Mobile Pentium® II Processor Specification Update

Release Date: October 1999

Order Number: 243887-014

The Mobile Pentium® II processor or the Intel® Pentium® II Processor Mobile Module may contain design defects or errors known as errata which may cause the product to deviate from published specifications. Current characterized errata are documented in this Specification Update.

OLD MOBILE PENTIUM® II PROCESSOR IN MINI-CARTRIDGE PACKAGE LABEL WITH SUPPLIER
MATRIX MARK

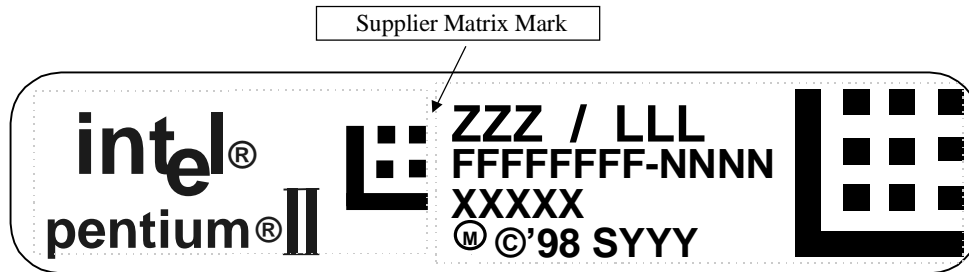
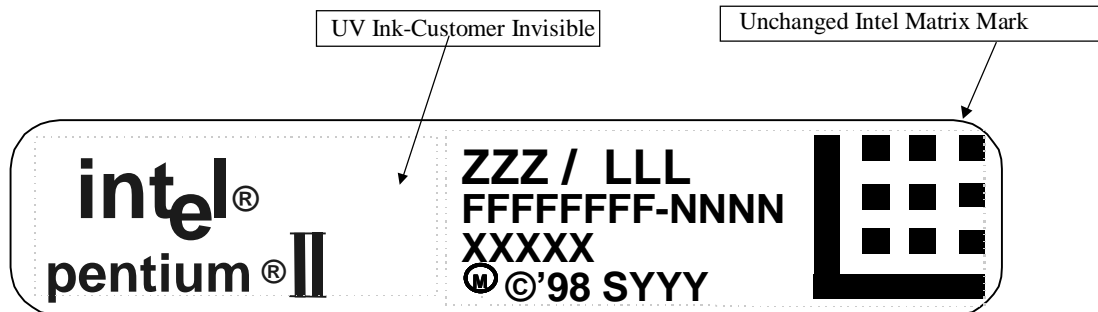
NEW MOBILE PENTIUM® II PROCESSOR IN MINI-CARTRIDGE PACKAGE LABEL WITH SUPPLIER MATRIX
MARK REMOVED

Figure 5.6. Cross Sectional View with Vertical Dimensions

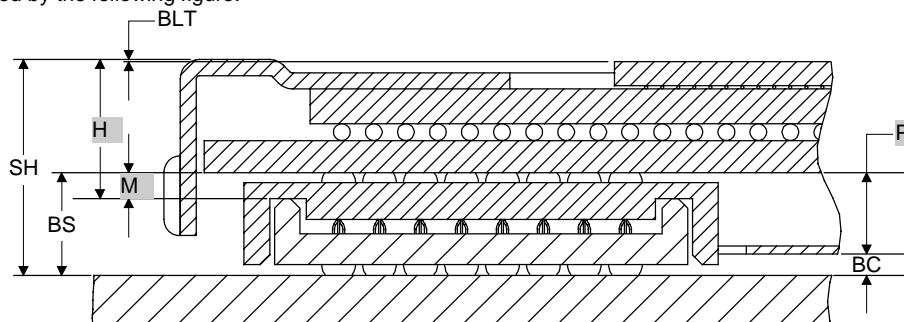
B1. Mislabeled Vertical Dimension Parameters

Figure 5.6 in the *Mobile Pentium® II Processor at 233 MHz, 266 MHz, and 300 MHz* datasheet should be replaced by the following figure:

Figure 5.3. Surface-Mount BGA1 Package—Top and Side View

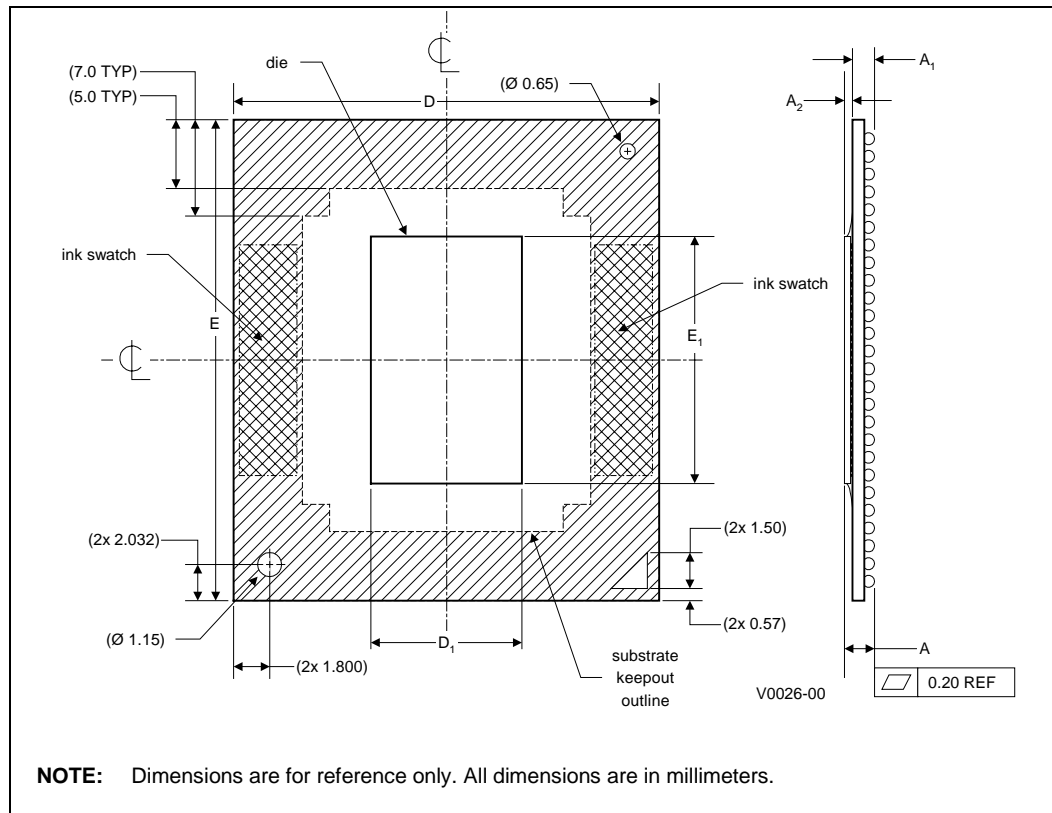
The following table and figures show the updated mechanical specifications for the BGA1 package, listed as Table 5.2, Figure 5.3 and Figure 5.4, respectively, in the *Mobile Pentium® II Processor in BGA Package at 366 MHz, 333 MHz, 300PE MHz, and 266PE MHz* datasheet.

Figure 3.3 Generic Clock Waveform

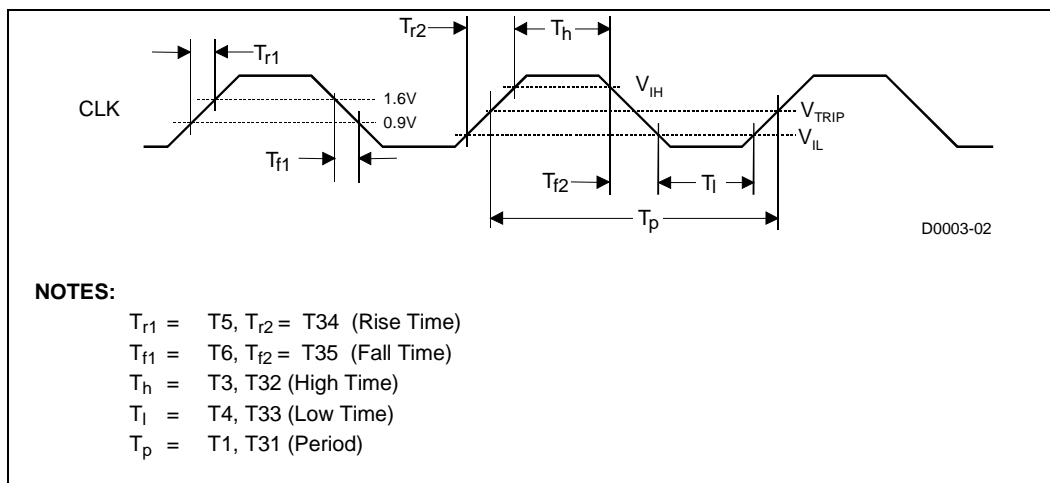
B14. Generic Clock Waveform Figure

Figure 3.3 in *Mobile Pentium® II Processor in Mini-Cartridge Package at 366 MHz, 333 MHz, 300PE MHz, and 266PE MHz* datasheet (Order Number 245108), and the *Mobile Pentium® II Processor in BGA Package at 366 MHz, 333 MHz, 300PE MHz, and 266PE MHz* datasheet (Order Number 245106) has been updated. The following figure is to replace the ones in the above documents.

Figure 1. TAP Gageable Thread Clarification

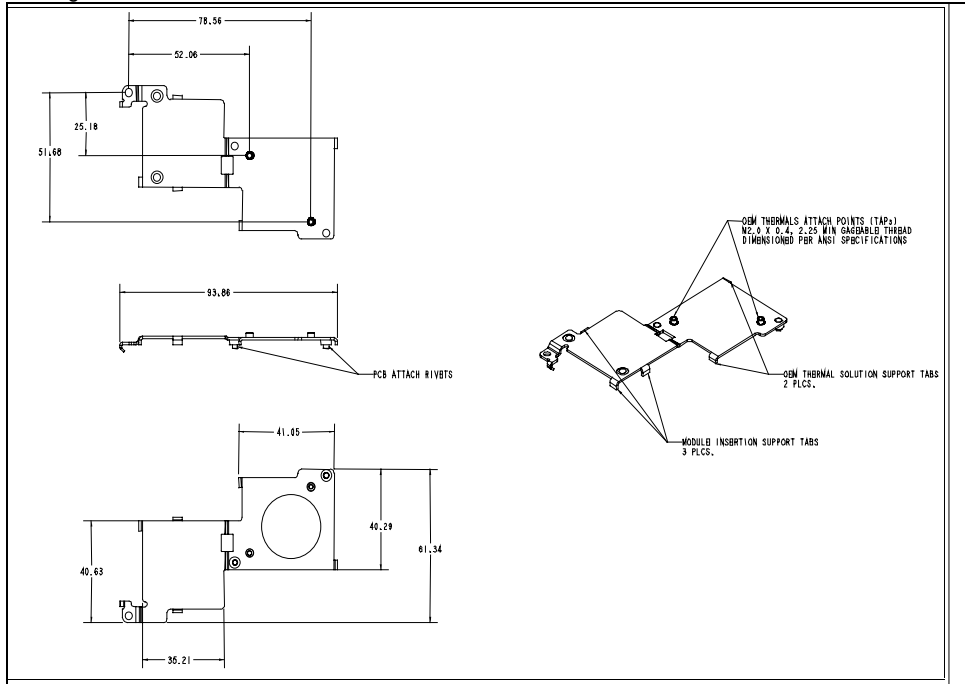
In the *Intel® Pentium® II Processor Mobile Module : Mobile Module Connector 1 (MMC-1)* and the *Intel® Pentium® II Processor Mobile Module : Mobile Module Connector 2 (MMC-2)* datasheets (Order Numbers 243667 and 243668, respectively), the thermal attach point (TAP) gageable thread specification was not clearly identified in Figure 14, of Section 5.2. The following is the TAP clarification:

OEM Thermal Attach Points (TAPs) M2.0 x 0.4, 2.25 min gageable thread dimensioned per ANSI specification.

See Figure 1 below for more information.
